DR 07-04 – American Steel – An application requesting Site and Design Review for approval for a 190,585 sq ft building with a screened yard to the south to accommodate the operations of American Steel. The site is located on 10.34 acres immediately north of the Southern Pacific railroad, south of Township Road, east of the existing BBC facility, and west of the proposed Sequoia Parkway extension (Walnut Street) in Canby.

STAFF REPORT

VLMK Consulting Engineers
3933 SW Kelly Avenue
Portland, OR 97239
(representing American Steel, LLC)

SITE PLAN

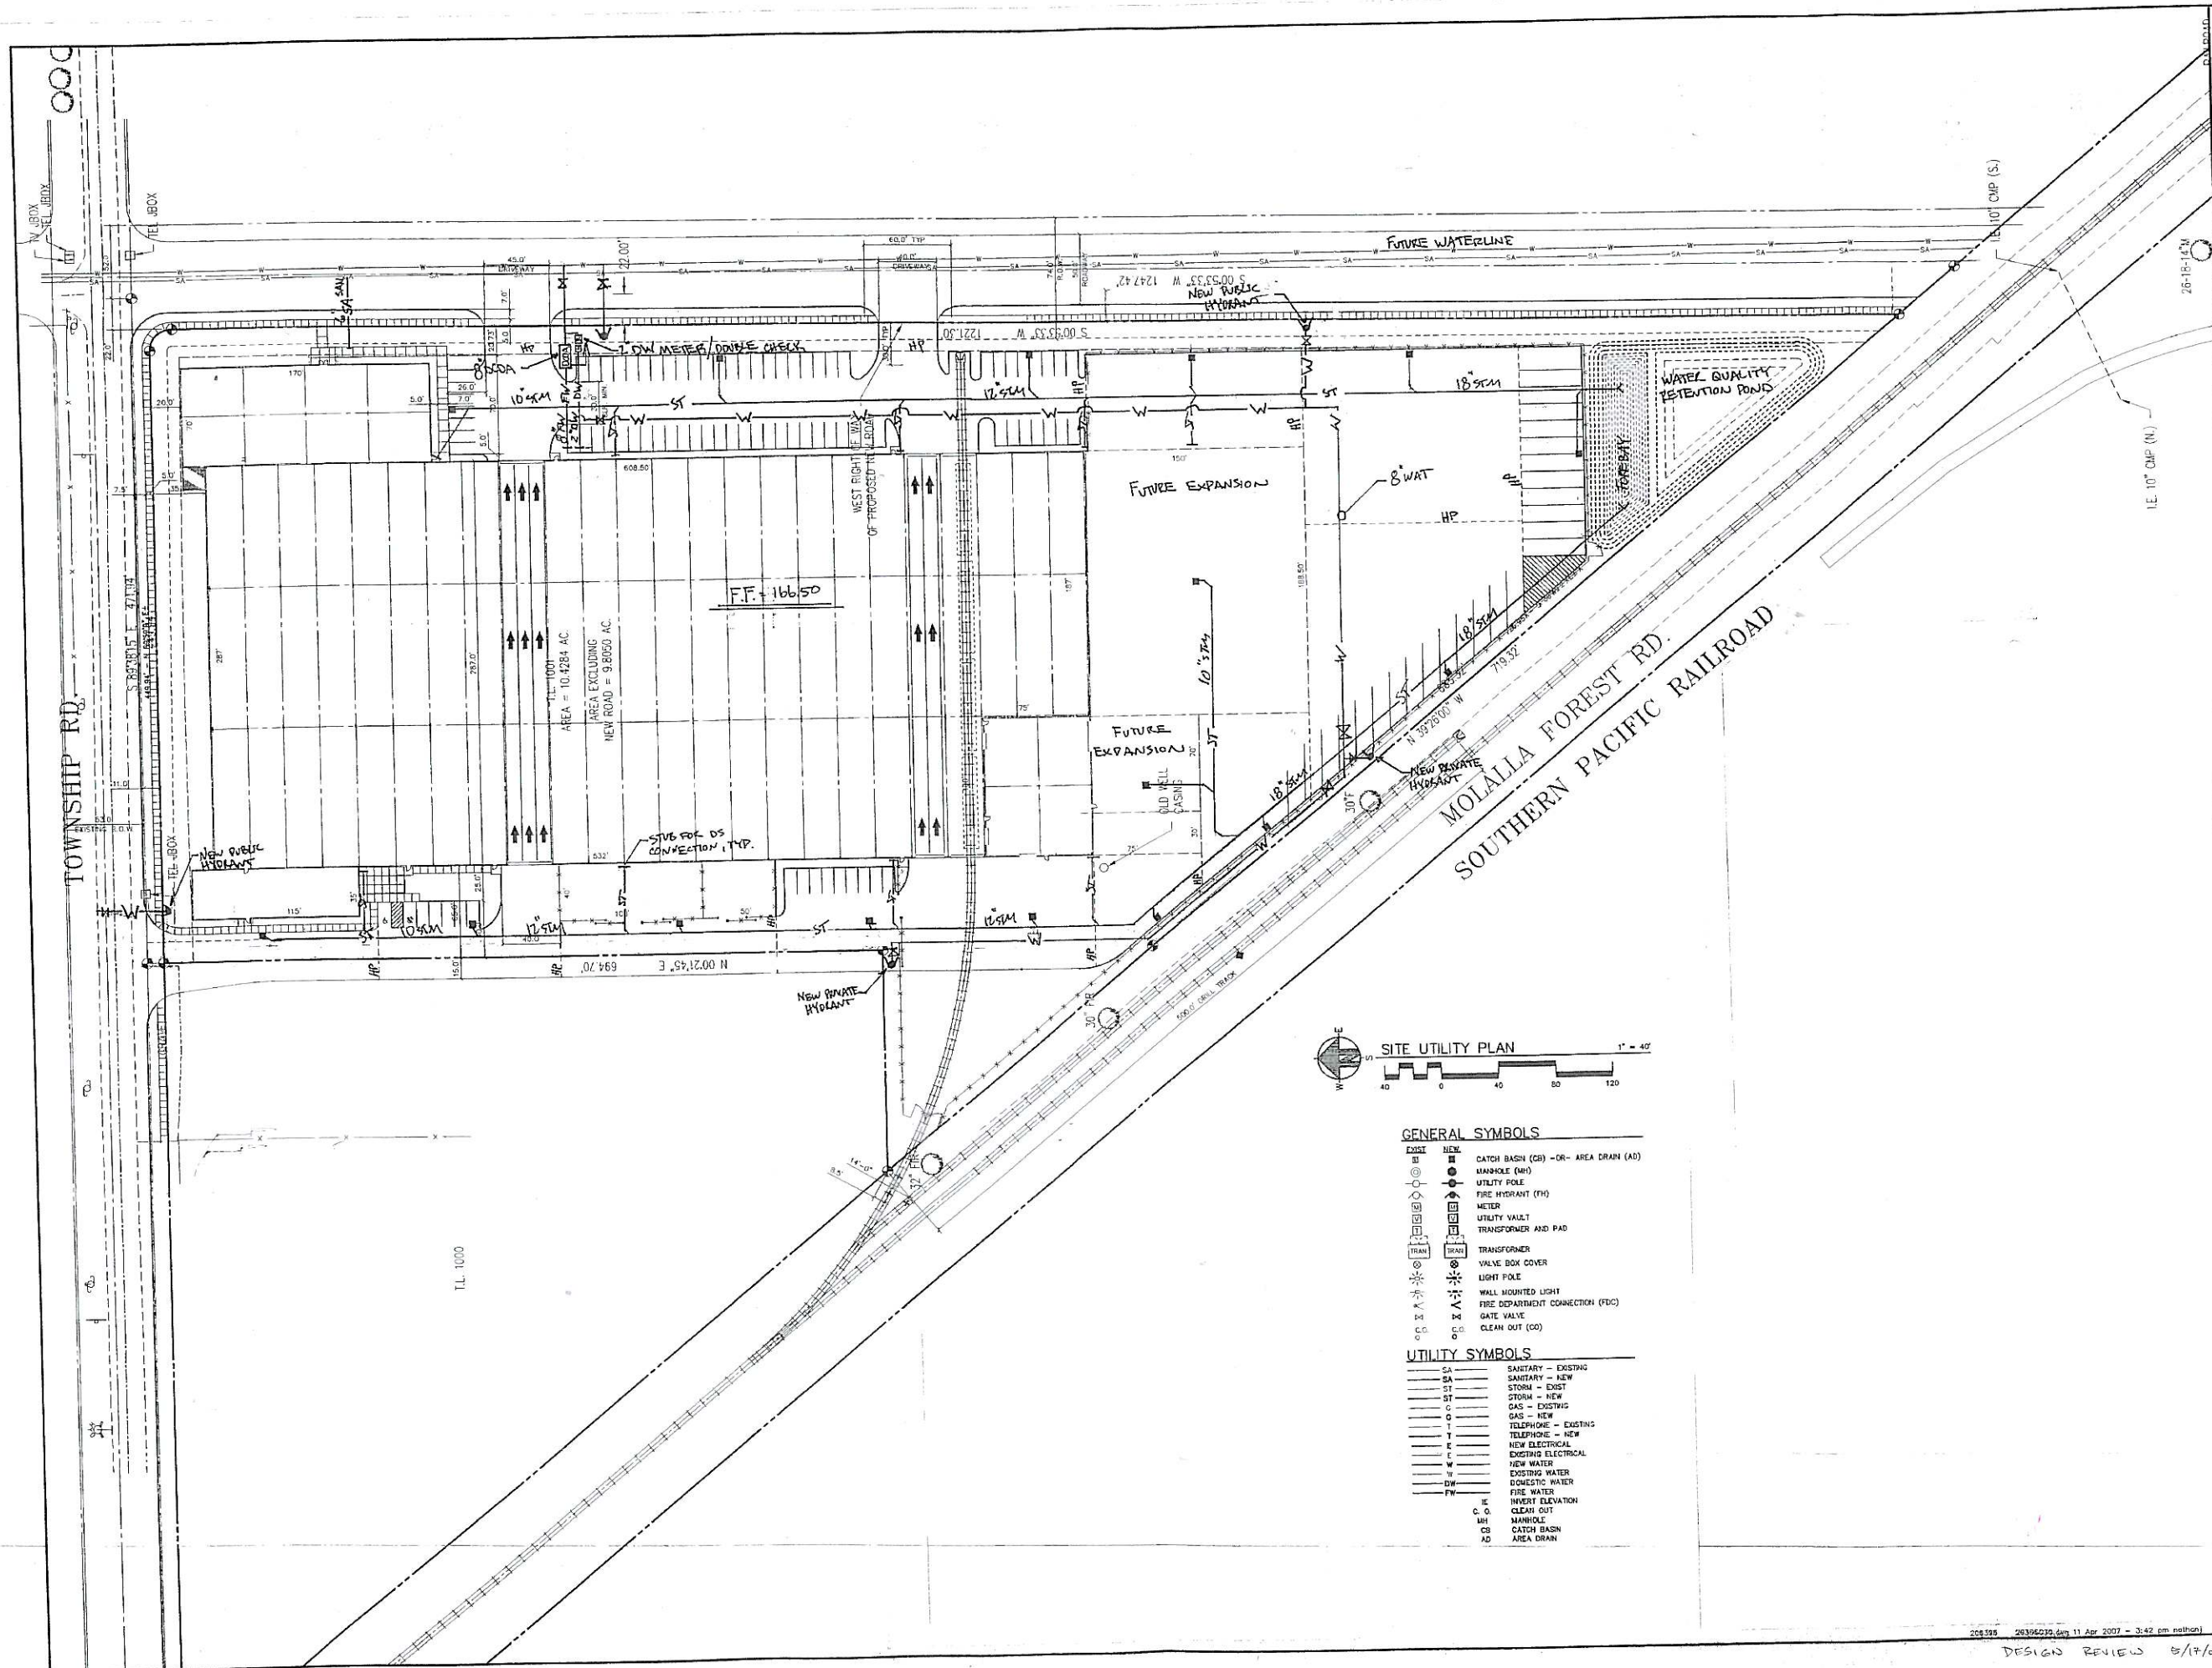
The intersection of Sequoia and Township will actually be slightly east of that shown on the site plan, so the actual layout will include slightly more landscaping between the building and sidewalk. Condition 13 reflects this design requirement.

The proposed site plan includes pedestrian connections to both office areas on the north side of the building. No sidewalks are proposed running along the parking areas. CMC 16.35.050I(1) requires a direct pedestrian connection between the primary building entrance and public sidewalk; staff believes a shorter path must be provided to meet this requirement (Condition 19).

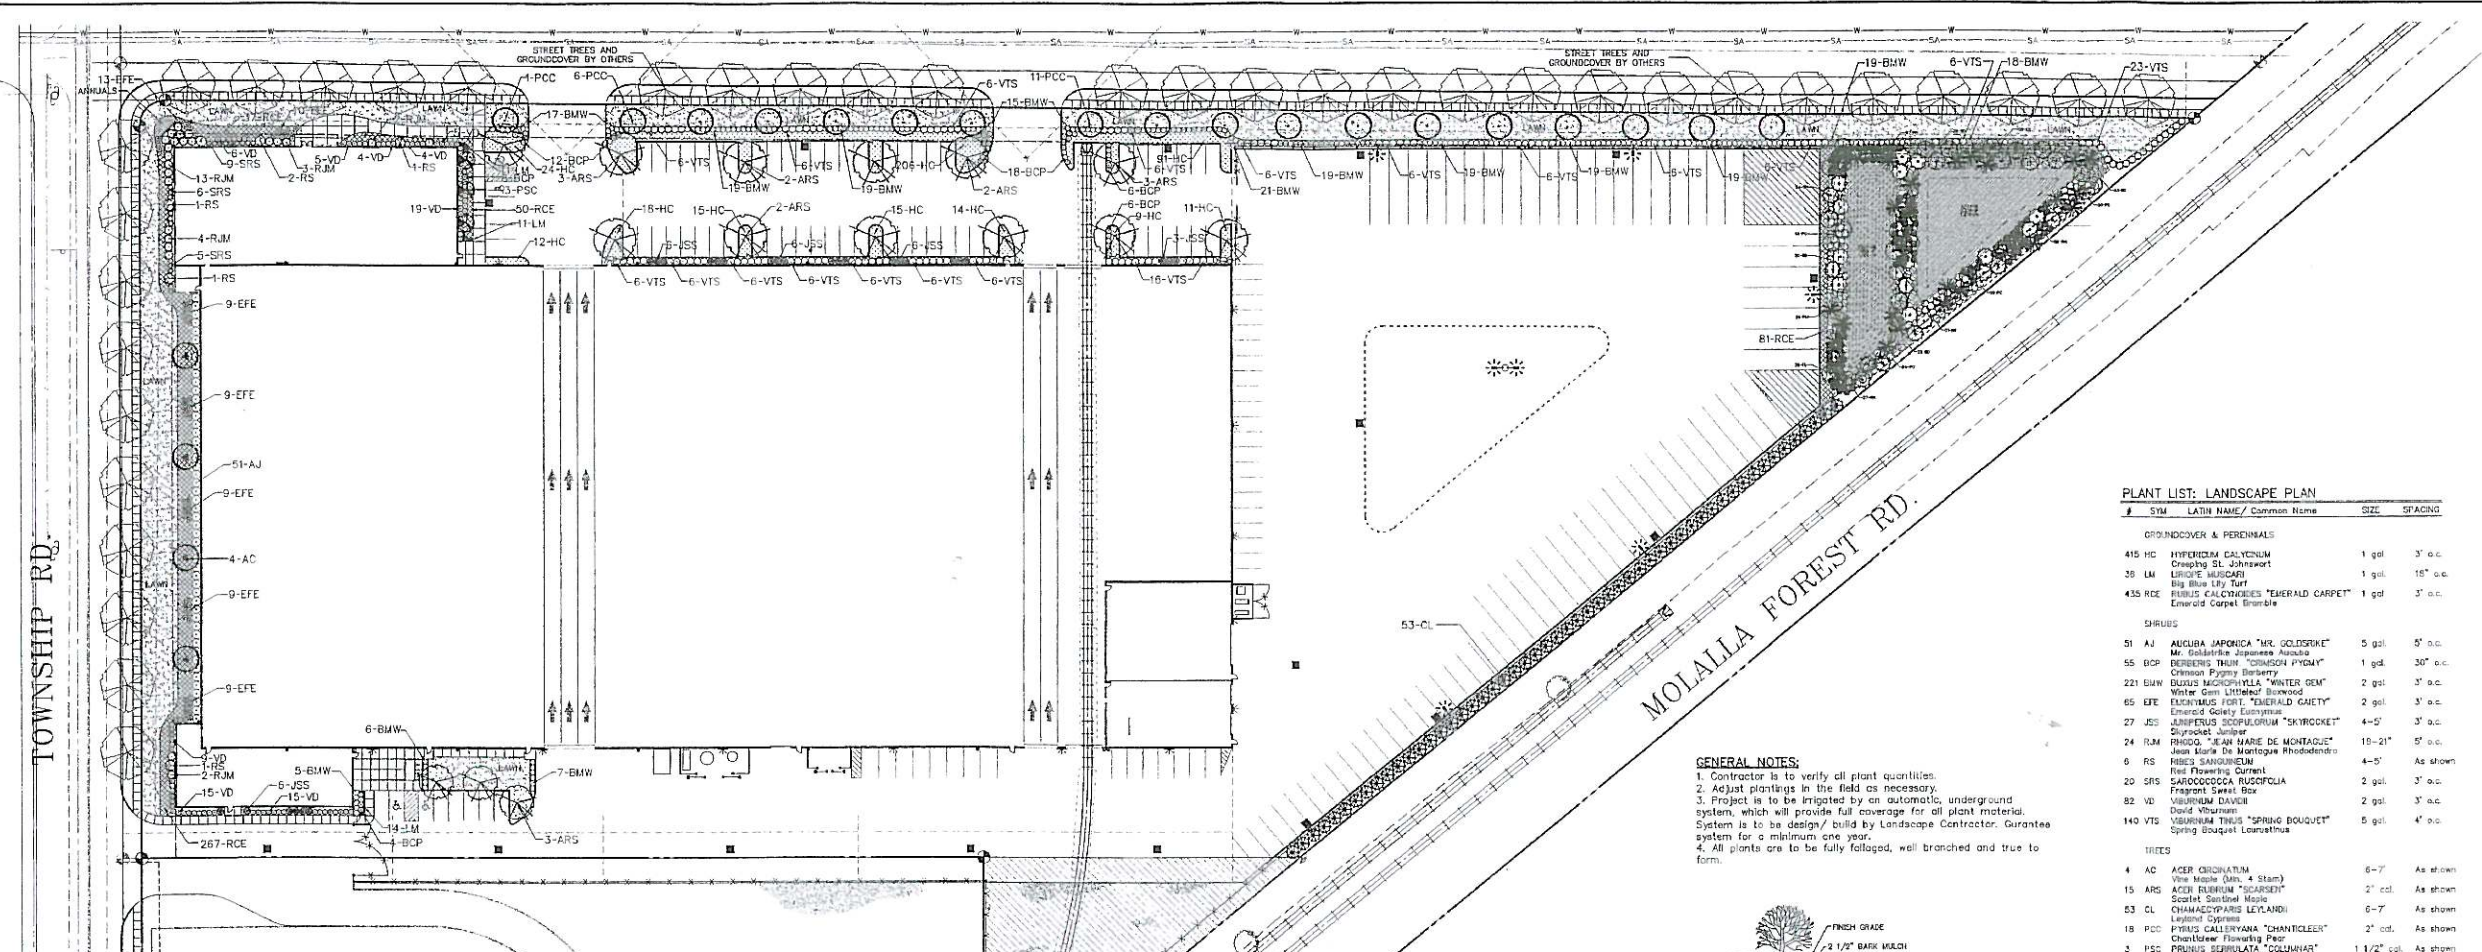
The site is lit by a combination of wall packs and light poles; illumination levels are shown on figure LT 1. The public parking areas achieve at least 0.25 foot-candles (FC) with most areas above 1 FC. The enclosed storage yard is lit as well, generally at 0.25 FC and above. Street lights will be installed as part of road construction and will add to these lighting levels. Condition 27 requires hooded or cutoff fixtures to minimize light pollution.

LANDSCAPE PLAN
 1"=40'-0"

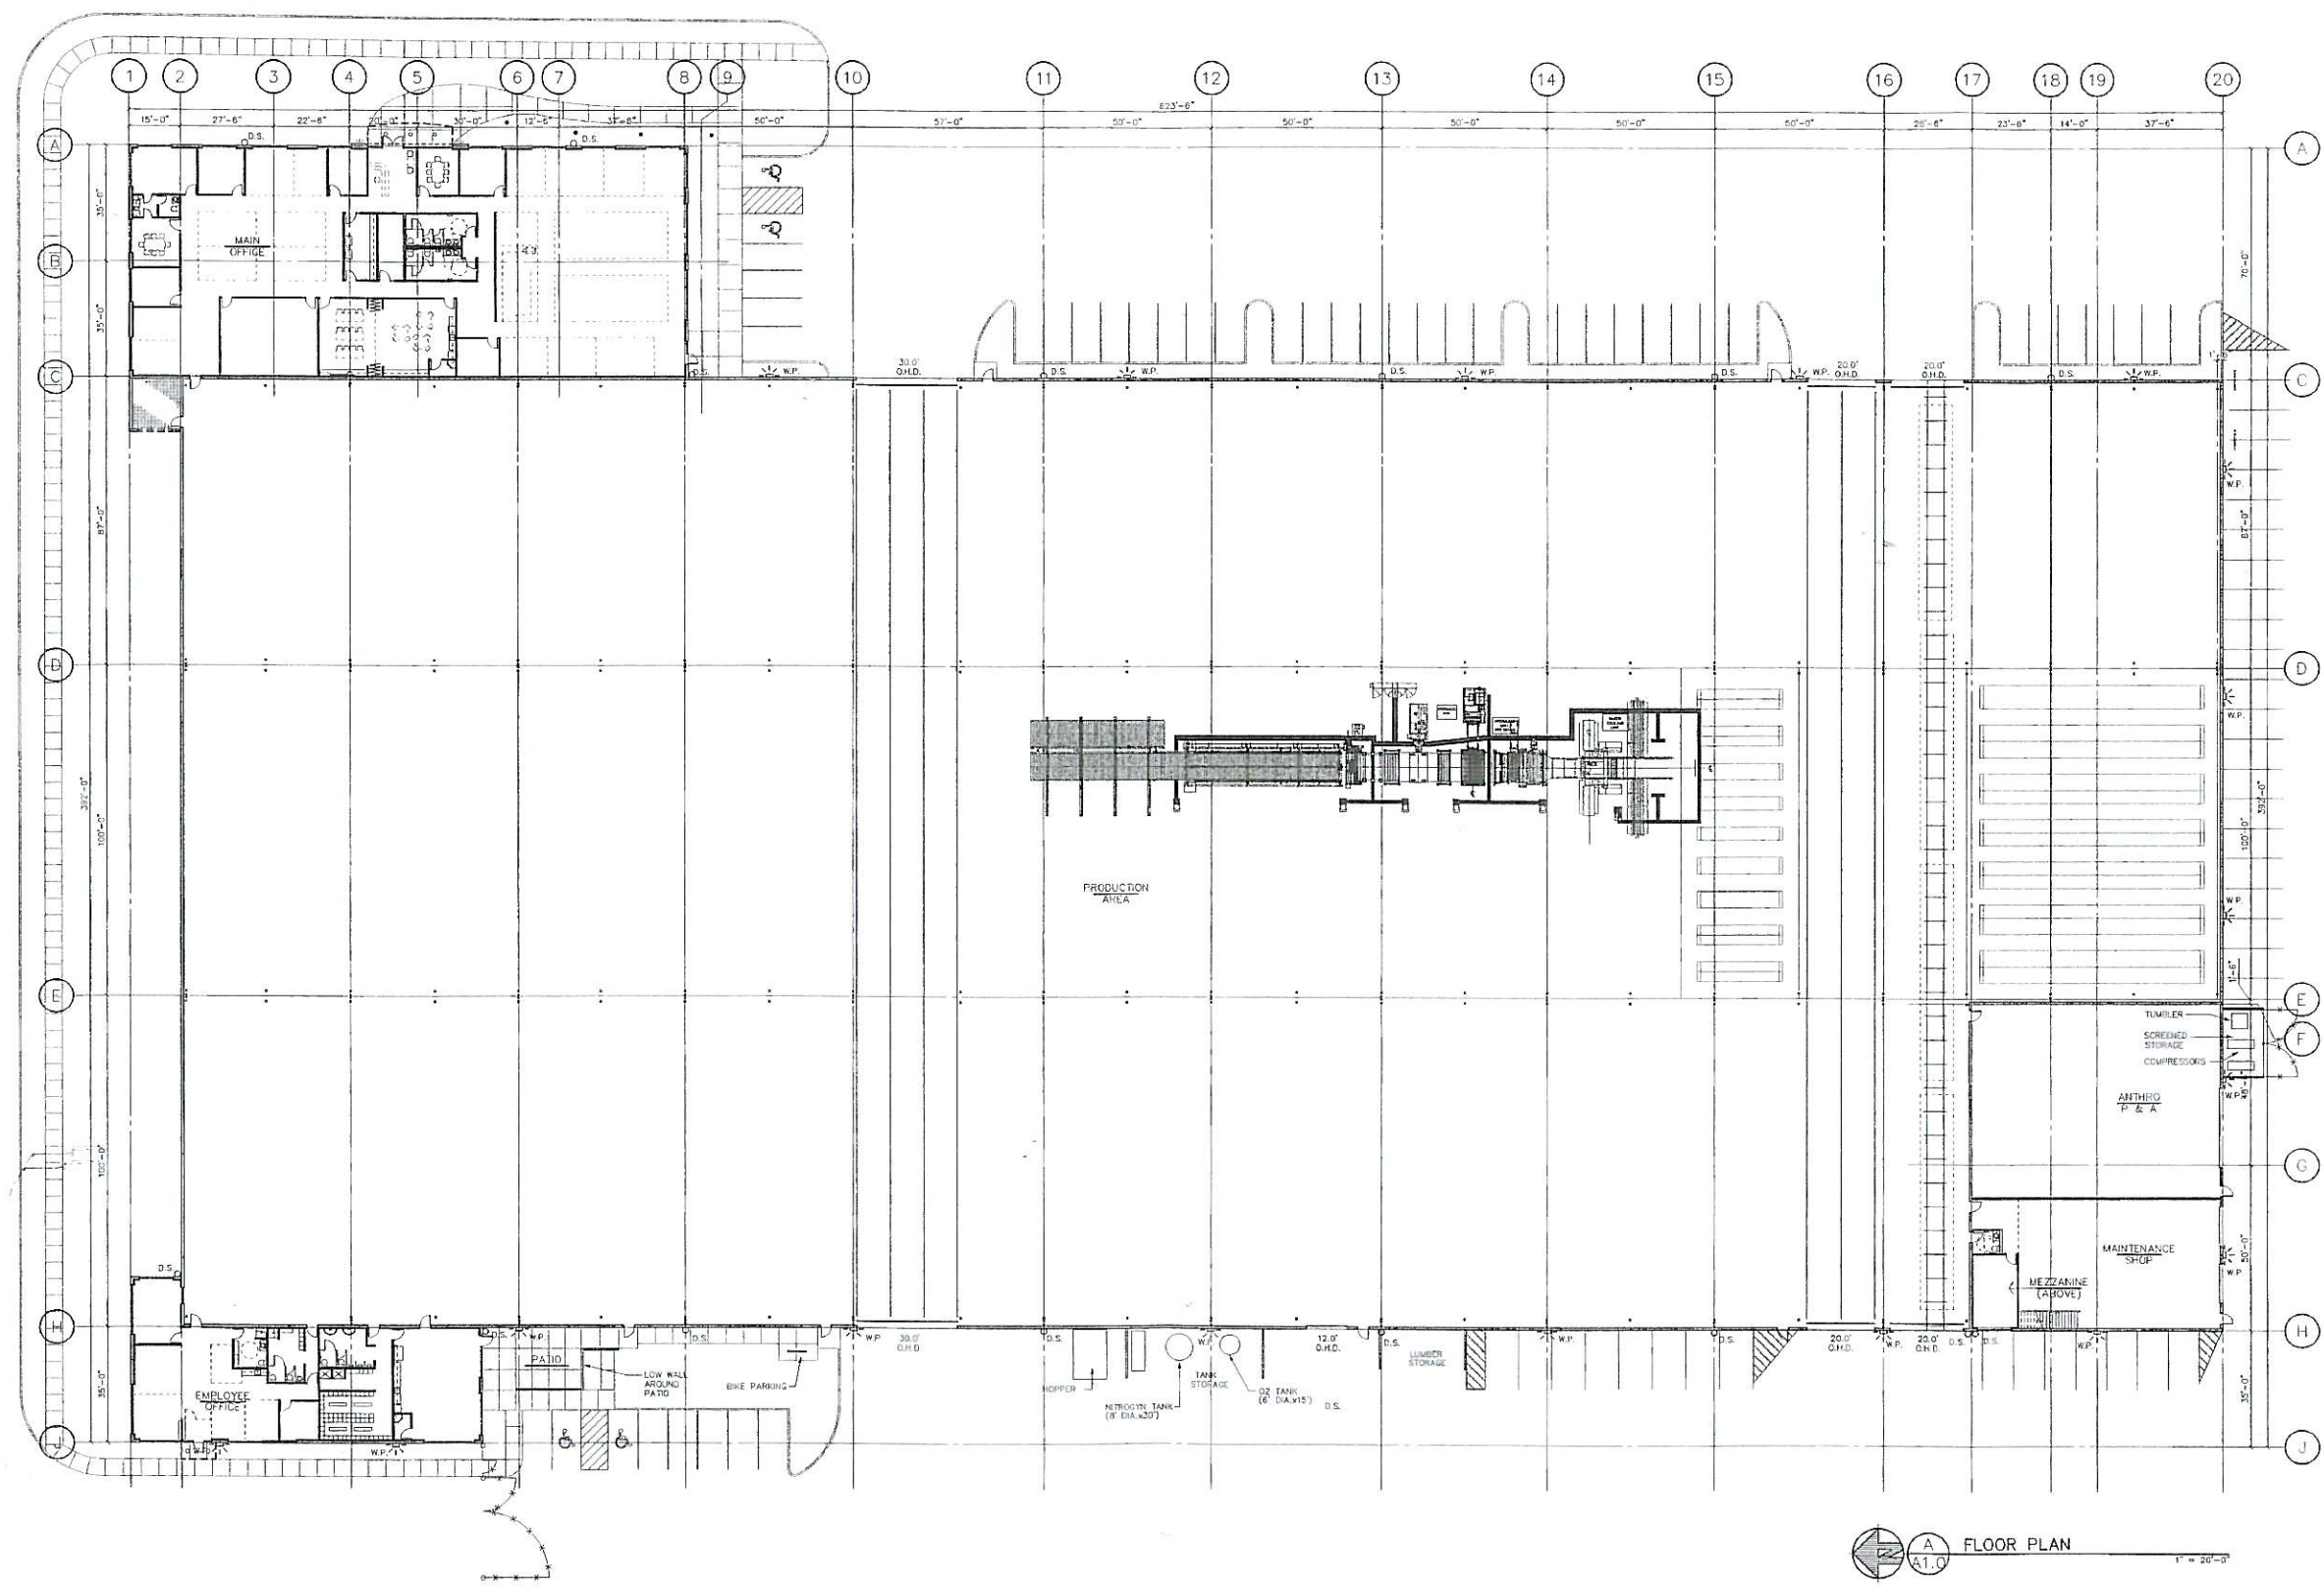
The landscape plan calls for “Street Trees and Groundcover by others” in the planter strip, but that work is required of the applicant according to municipal code and the memorandum of understanding with the property owners. Conditions 11 and 14 require the applicant to plant street trees with species and spacing approved by the City in the planter strip, and to plant grass with automatic irrigation. Street trees will be large deciduous trees such as maples or oaks to match previous phases of Sequoia Parkway.
